# Access Compliance Report

## Public Rights-of-Way (Curb Ramps)

Intersection ID: 31190	Main Street: CROFT_HAVEN_DR	Cross Street: DAVIS_RIDGE_DR	Location: NE
ADA ID: 5ACD35BC6CAC	Ramp Type: PerpDiag	Initial Pass/Fail: Fail	Overall Compliance: No
Severity Score: 25			
Codes/Mitigation Info/Possible Solution		Field Measurements/Component Compliance

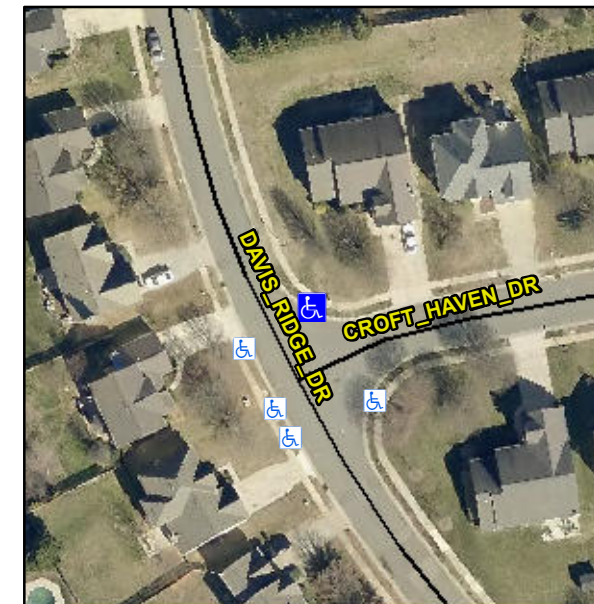
**Not Found, R304.5.3**

Compliance	Description	Data	Compliance	Description	Data
N/A	Ramp Length (in)	48.0	Yes	Ramp Slope (%)	8.3
Yes	Ramp Width (in)	48.0	No	Ramp XSlope (%)	7.3
N/A	Flare Type LT	N/A	N/A	Flare Type RT	N/A
N/A	Flare Slope LT (%)	N/A	N/A	Flare Slope RT (%)	N/A
N/A	Flare Traversable LT?	N/A	N/A	Flare Traversable RT?	N/A
N/A	Landing Length (in)	N/A	N/A	DWS Provided?	N/A
N/A	Landing Width (in)	N/A	N/A	DWS Contrast?	N/A
N/A	Landing Slope (%)	N/A	N/A	DWS Length (in)	N/A
N/A	Landing X Slope (%)	N/A	N/A	DWS Full Width?	N/A
N/A	Landing Curb? (Y/N)	N/A	N/A	DWS Offset (in)	N/A
N/A	Shared Landing?	N/A			
N/A	Gutter Ponding?	N/A	N/A	Gutter Slope (%)	N/A
N/A	Gutter Lip Ht (in)	N/A	N/A	Gutter X Slope (%)	N/A
N/A	Painted X Walk1?	No	N/A	Painted X Walk2?	No
	X Walk 1 Direction	To W		X Walk 2 Direction	To S
N/A	X Walk 1 Width (in)	N/A	N/A	X Walk 2 Width (in)	N/A
	X Walk 1 Slope (%)	5.6		X Walk 2 Slope (%)	5.9
	X Walk 1 X Slope (%)	6.4		X Walk 2 X Slope (%)	4.7

**Remove & Replace Curb Ramp With Two New Directional Ramps or Equivalent.**
